May 21, 2018
IDEA PUBLIC SCHOOLS – IDEA Brownsville Robindale Phase I

ADDENDUM NO. 1

A. PURPOSE AND INTENT
This addendum is issued for the purpose of modifying the plans and specifications for the IDEA PUBLIC SCHOOLS – IDEA Brownsville Robindale Phase I

Date: May 11, 2018
Scale: As Noted
Project Architect: David Monreal, AIA
Drawn By: JA, RB
Job No. IDEA Robindale Phase I
Sheet: A2.09

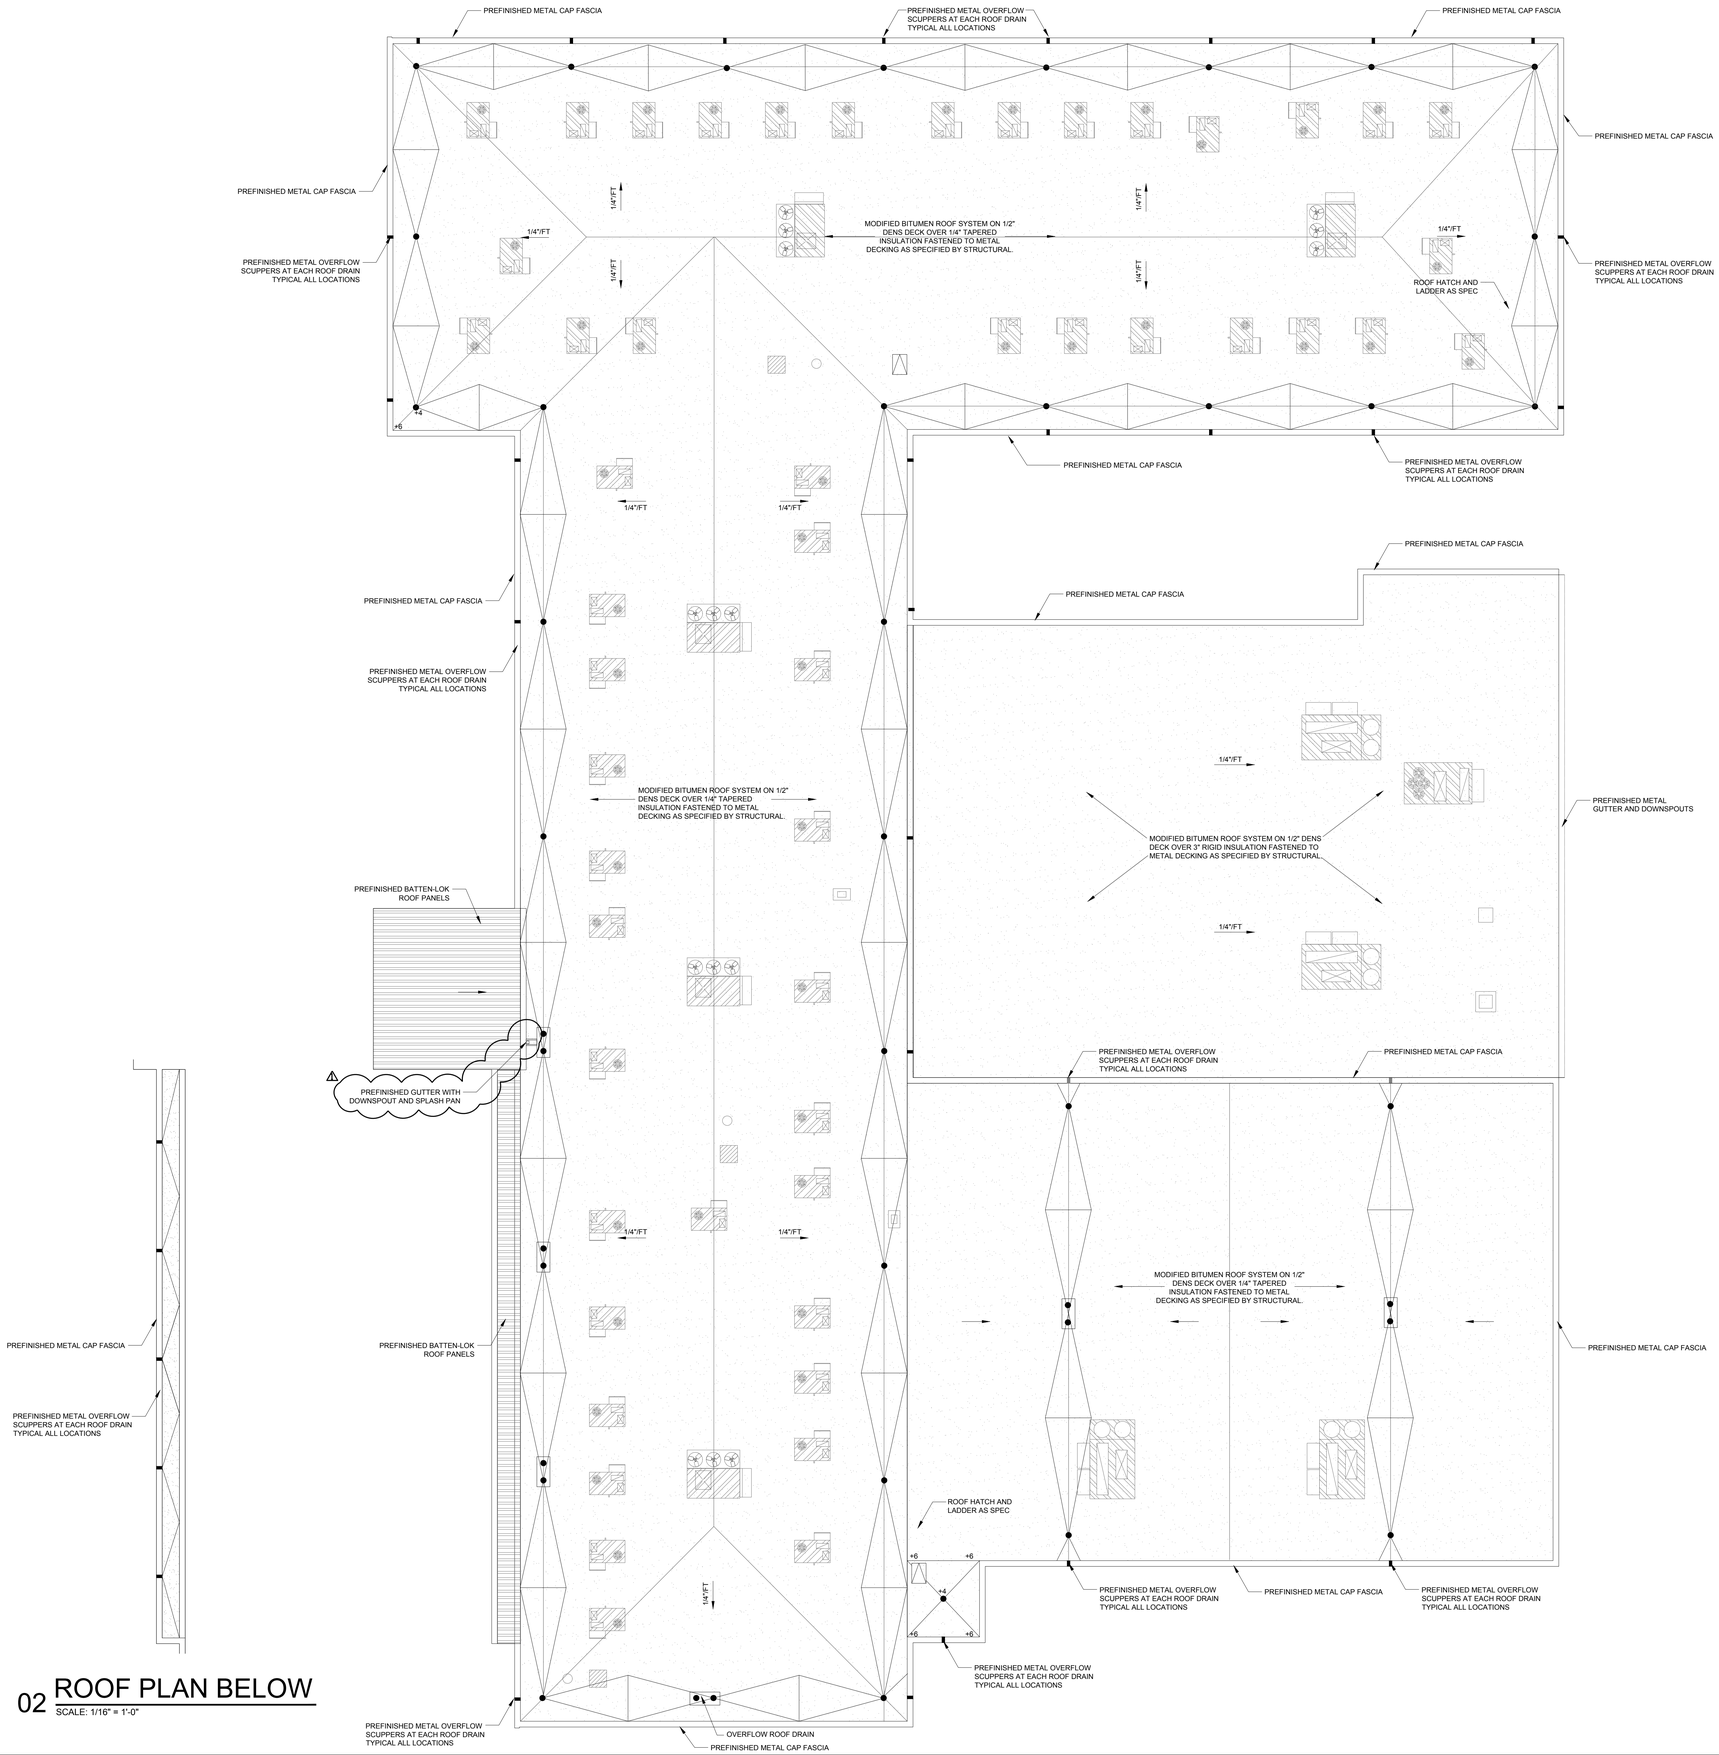
1. Sheet A2.09 – Roof Plan
    a. ADD Gutter and Downspout at back side of Entry Wall. Replace Sheet A2.09 previously issued with Sheet A2.09 included in this addendum.
2. Sheet A2.12 – VCT Pattern and Accent Walls
    b. REVISED Panel Signage at Offices and Support Spaces. Replace Sheet A2.12 previously issued with Sheet A2.12 included in this addendum.
3. Sheet A4.09 – Building Section
    c. REVISED Section Notes. Replace Sheet A4.09 previously issued with Sheet A4.09 included in this addendum.
4. Sheet A4.10 – Building Section
    d. REVISED Section Notes. Replace Sheet A4.10 previously issued with Sheet A4.10 included in this addendum.

Date: May 10, 2018
Scale: As Noted
Project Architect: David Monreal, AIA
Drawn By: ETHOS
Job No. IDEA Robindale Phase I
Sheet: MEP1.01

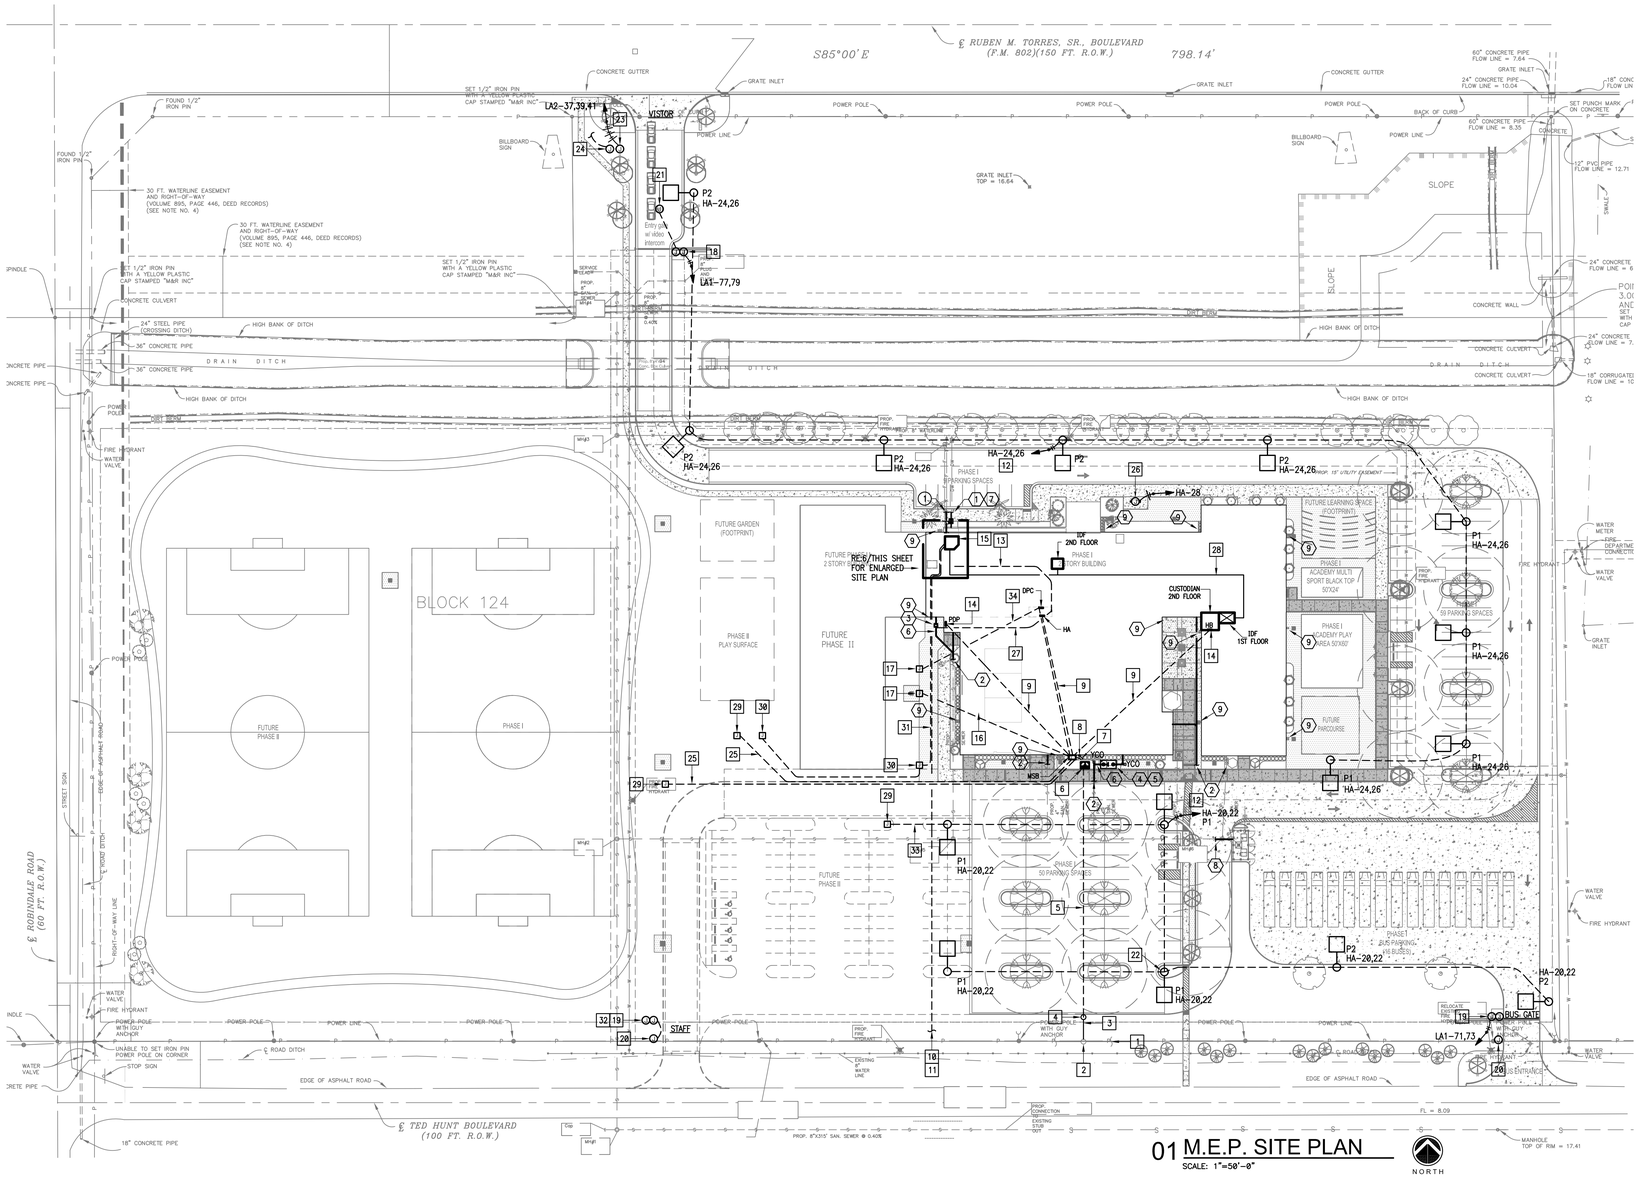
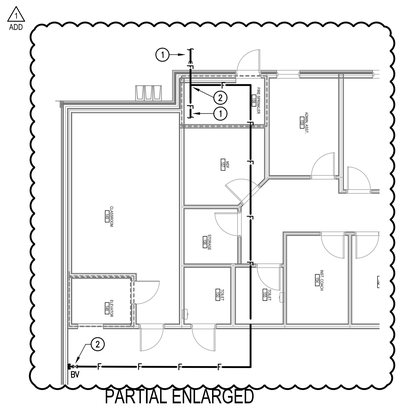
1) Sheet MEP1.01:
   a) Fire Riser Room enlargement has been revised. See attached sheet.

Date: May 10, 2018
Scale: As Noted
Project Architect: David Monreal, AIA
Drawn By: ETHOS
Job No.: IDEA Robindale Phase I
Sheet: E3.01

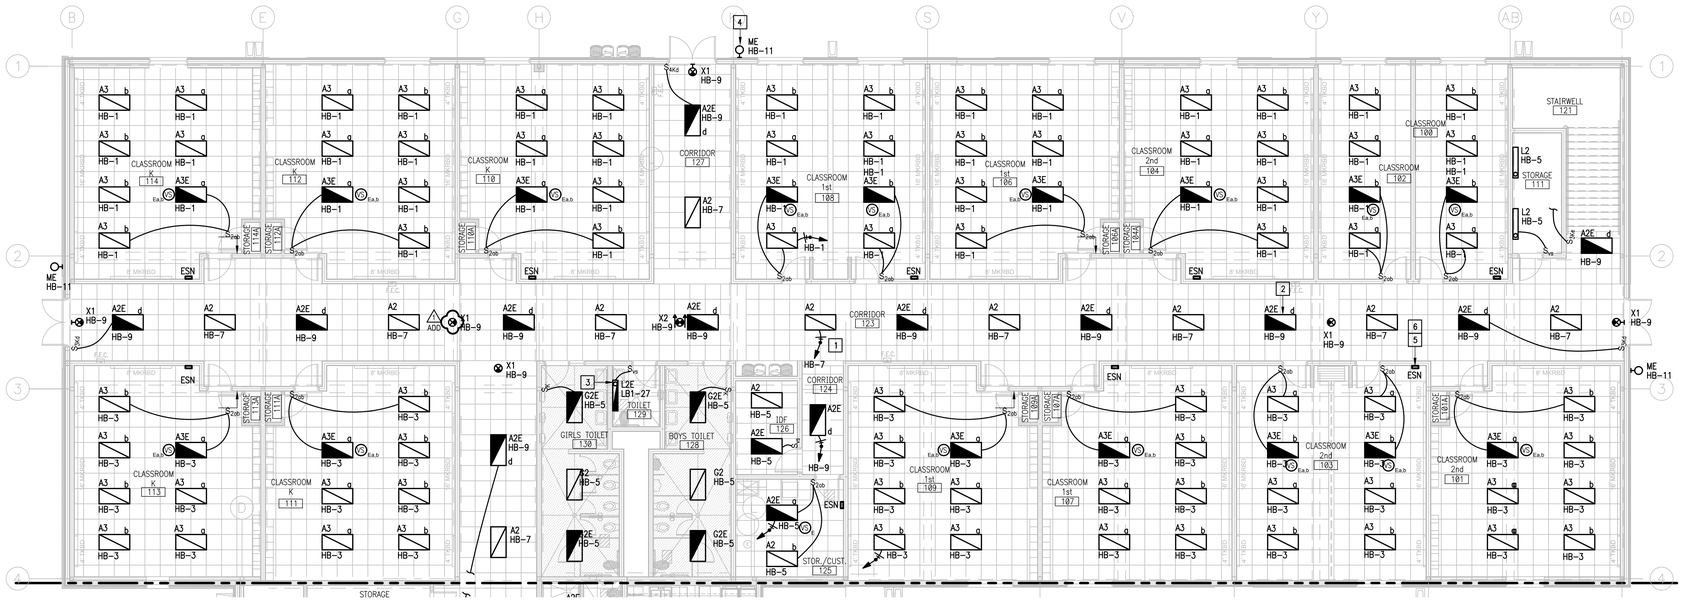
4) Sheet E3.01:
   b) Revised First Floor Lighting Plan. See attached sheet.

Date: May 10, 2018
Scale: As Noted
Project Architect: David Monreal, AIA
Drawn By: ETHOS
Job No.: IDEA Robindale Phase I
Sheet: E3.02

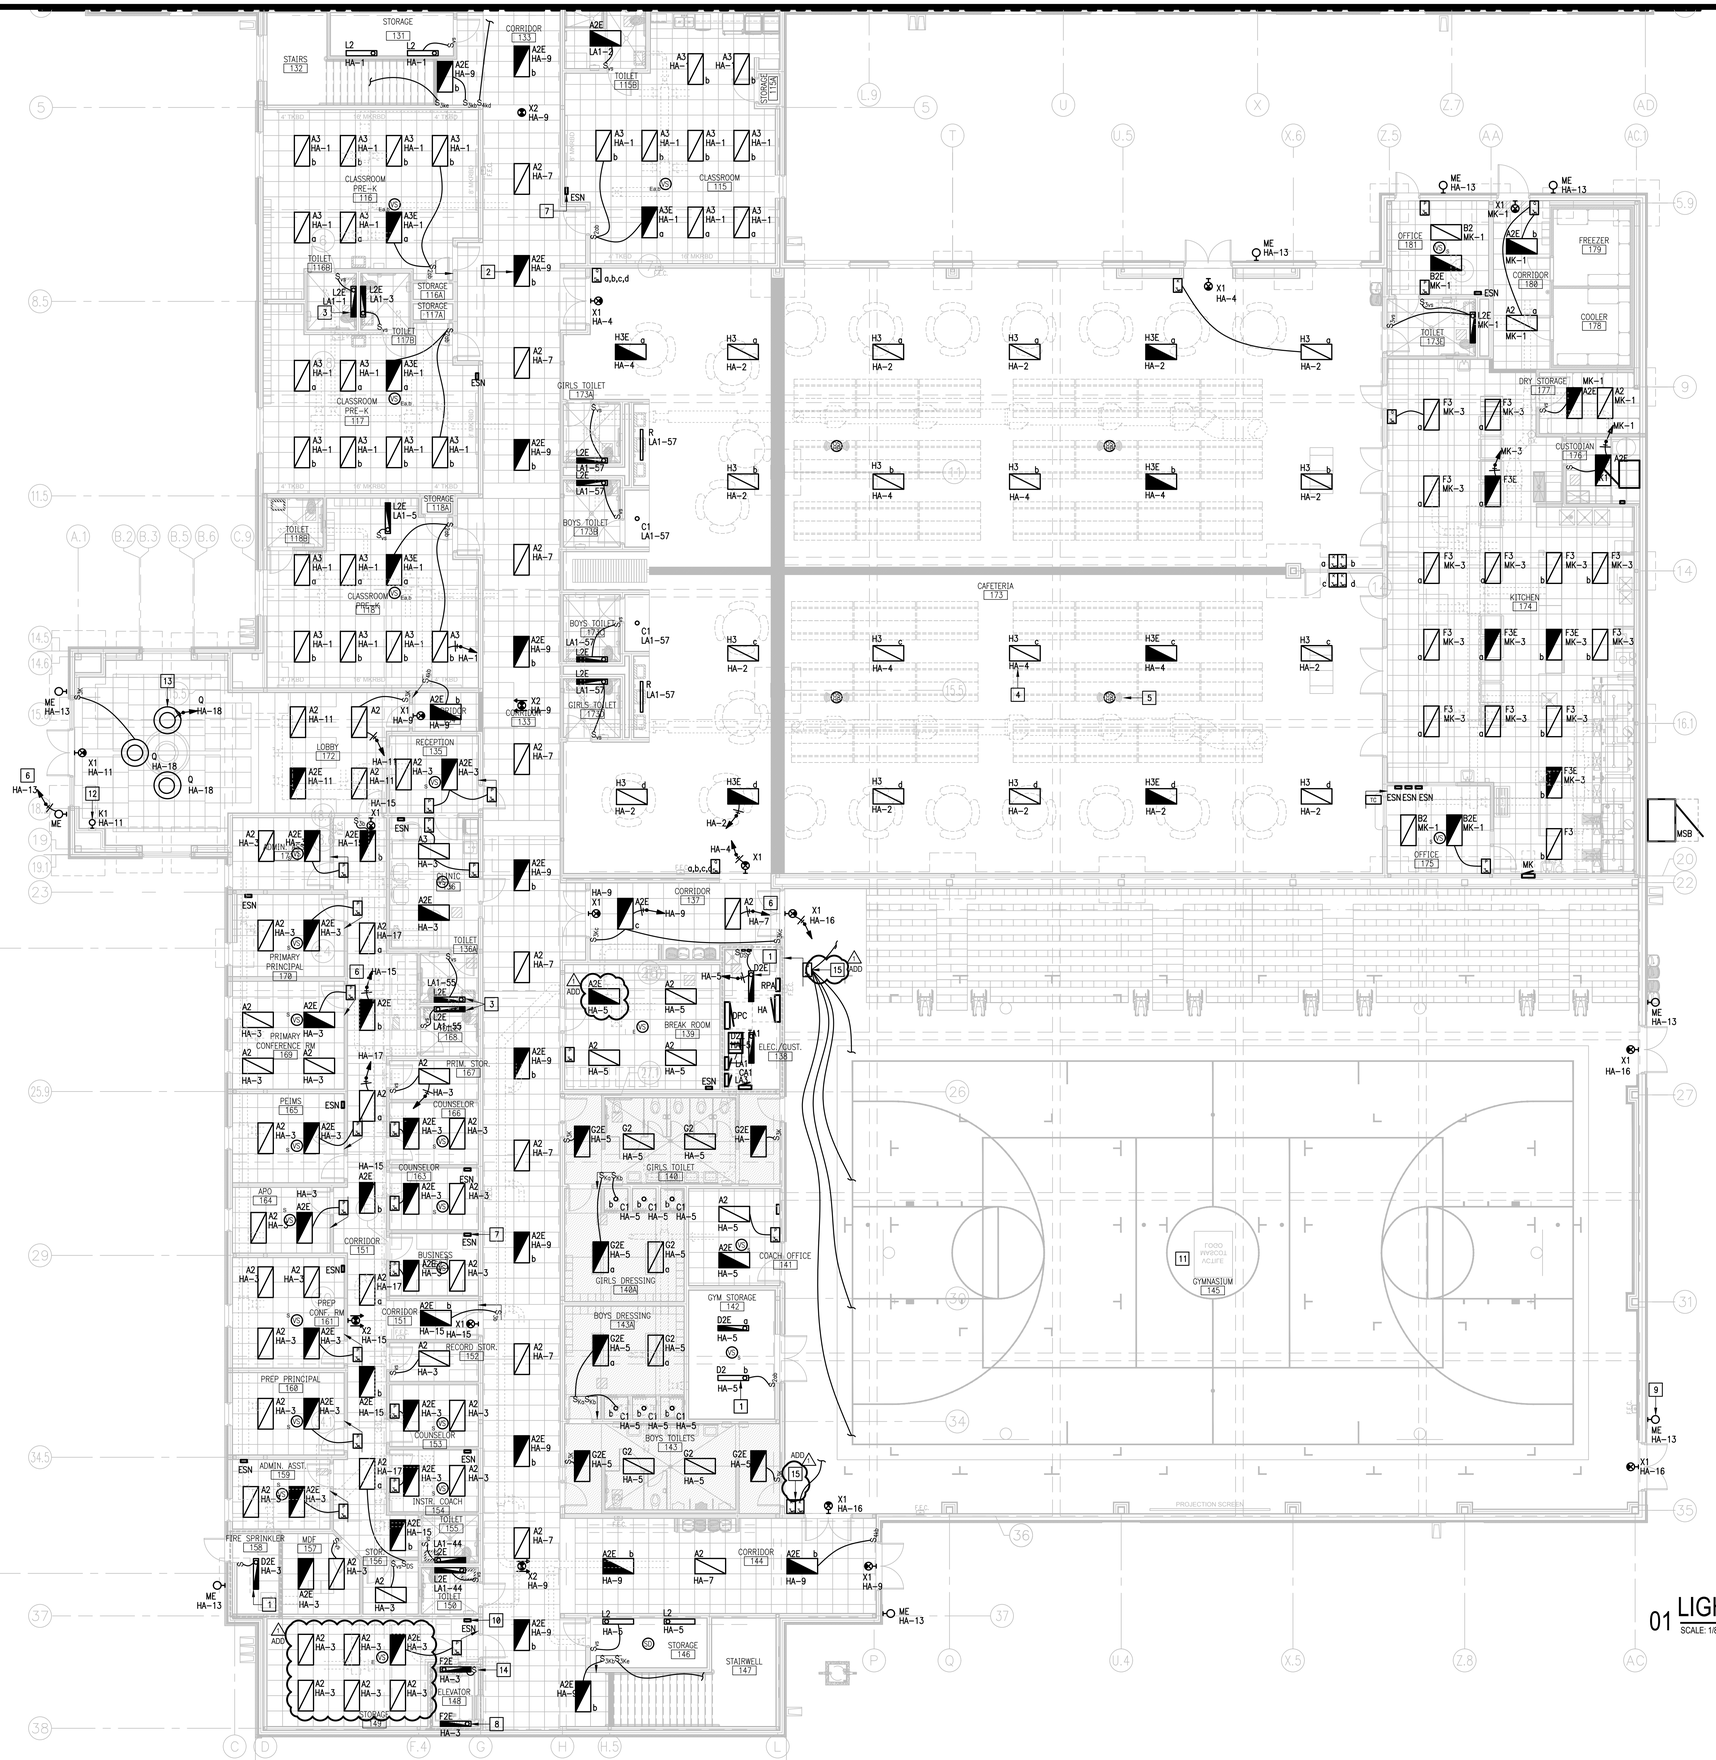
5) Sheet E3.02:
   a) Revised First Floor Lighting Plan. See attached sheet.

Date:	May 10, 2018
Scale:	As Noted
Project Architect:	David Monreal, AIA
Drawn By:	ETHOS
Job No.	IDEA Robindale Phase I
Sheet:	E3.03

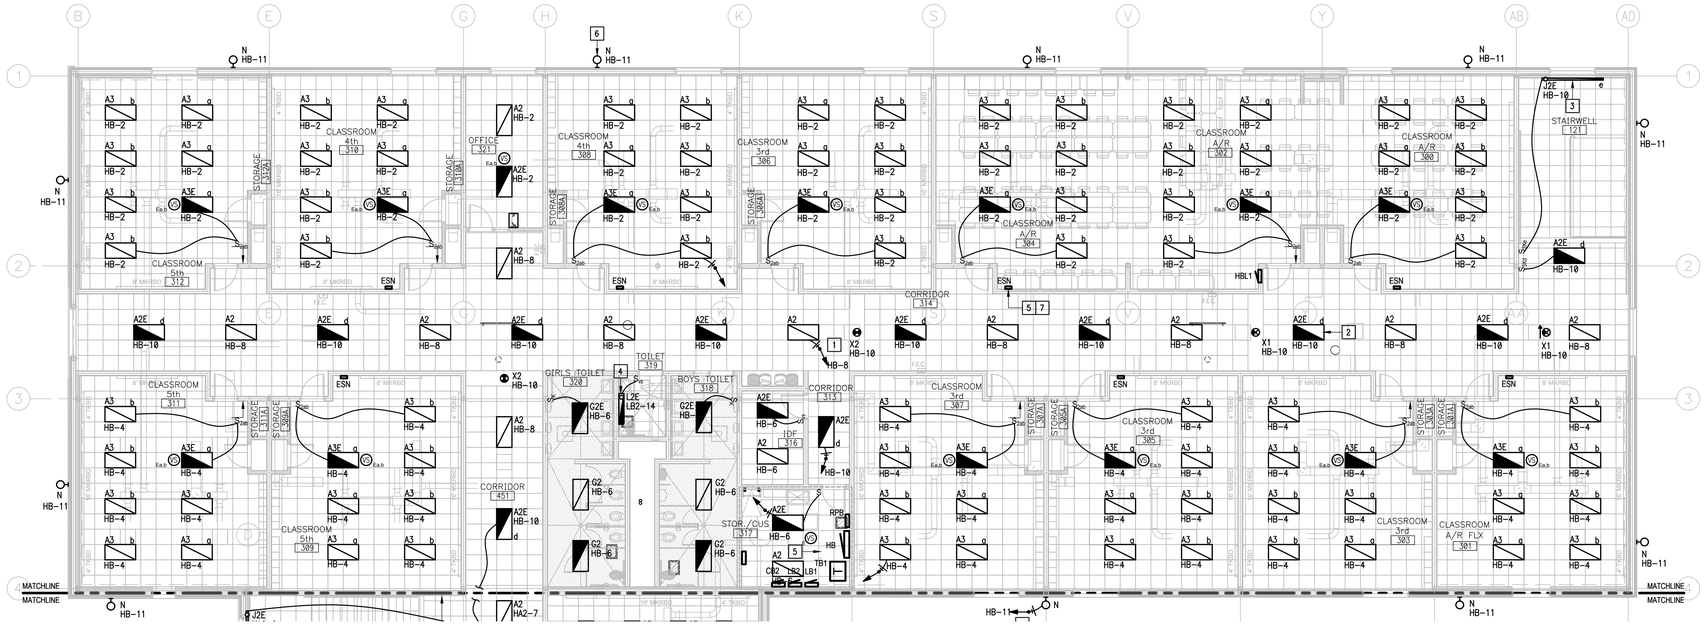
6) Sheet E3.03:
   a) Revised Second Floor Lighting Plan. See attached sheet.
